AS-BUILT PLANS

PRIVATE PROJECT SANITARY SEWER

2000 E 37th Street

2023-034722PPS

Line 1

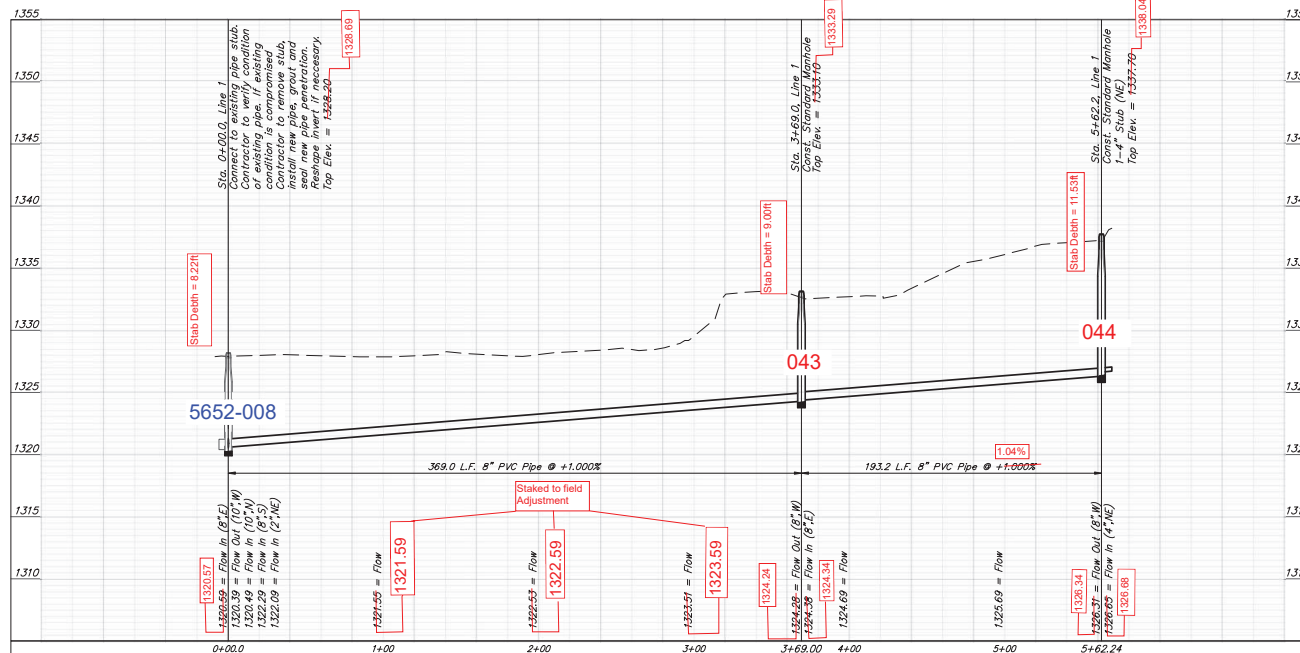
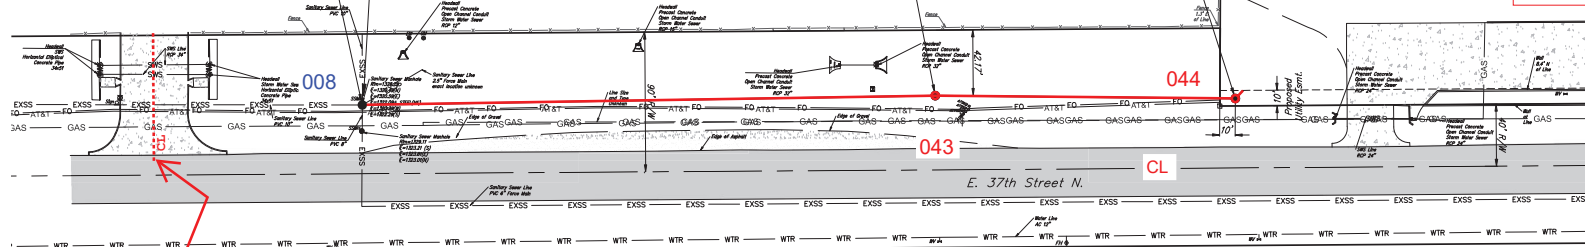
Sta. 0+00.0, Line 1
Connect to existing pipe stub.
Contractor to verify condition
of existing pipe. If existing
condition is compromised
Contractor to remove stub,
install new pipe, grout and
seal new pipe penetration.
Reshape invert if necessary.
Top Elev. = 1328.20
N. 1,709,817.44
E. 1,654,976.20

Top Elev. = 1328.69
N: 1,709,817.47
E: 1,654,976.21

~~If 2.5" force main is in conflict with new sanitary, remove from existing manhole at STA 0+00 and connect to new manhole at STA 5+62. Repair pipe penetration in existing manhole with brick and non-shrink grout.~~

Top Elev. = 1333.29
N: 1,709,828.27
E: 1,655,345.01

Sta. 5+62.2, Line 1
Const. Standard Manhole
1-4" Stub (NE)
~~Top Elev. = 1337.70~~
~~N: 1,709,828.19~~
~~E: 1,655,538.29~~
Top Elev. = 1338.04
N: 1709828.16
E: 1655538.30
